Westwood Shopping Center, Sketch Plan No. 320170010

Completed: 02/10/2017

Description

EXHIBIT 2: ALTERNATIVE RIGHT-OF-WAY CROSS SECTION

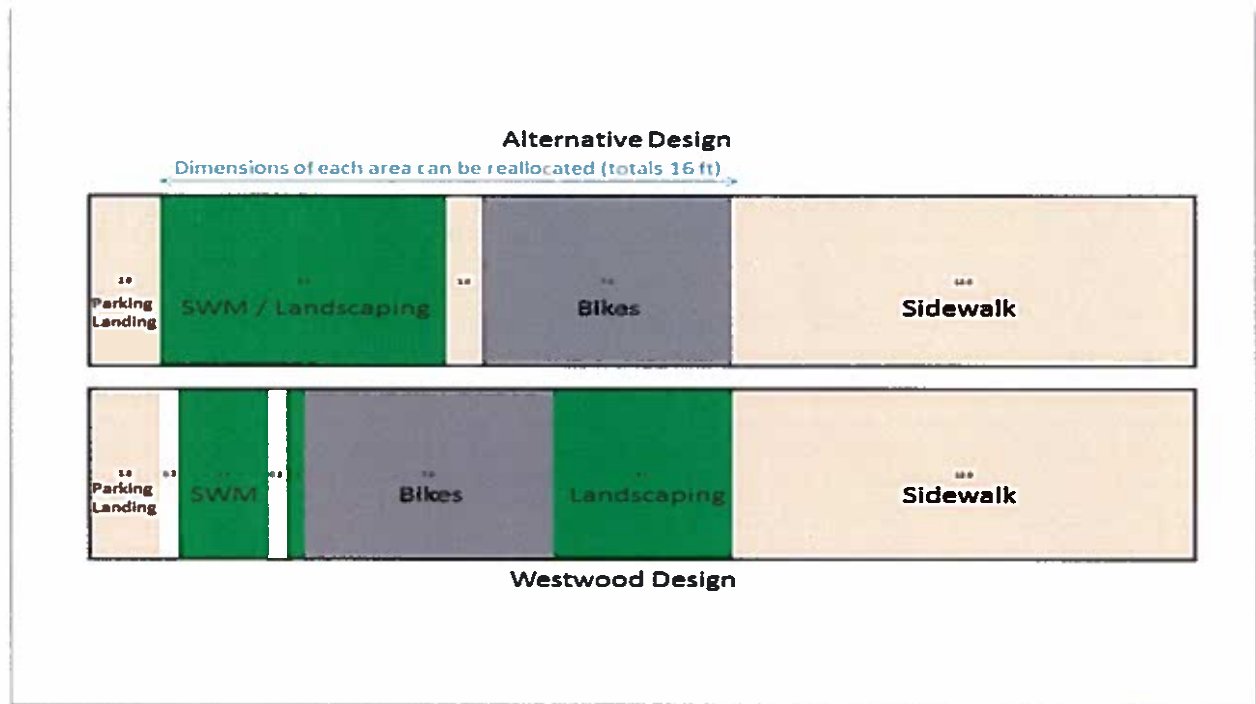
2. At the preliminary plan stage, provide a typical section in accordance with the latest master plan.
 - a. Consider modifying the section (p. 30 of the Westbard Sector Plan) to combine the two green space sections into a single eight (8) foot SWM/landscaping section, with a two (2) foot parking landing on one side and a one (1) foot separation between the cycle track. All other dimensions would remain the same. See attached EXHIBIT 2.
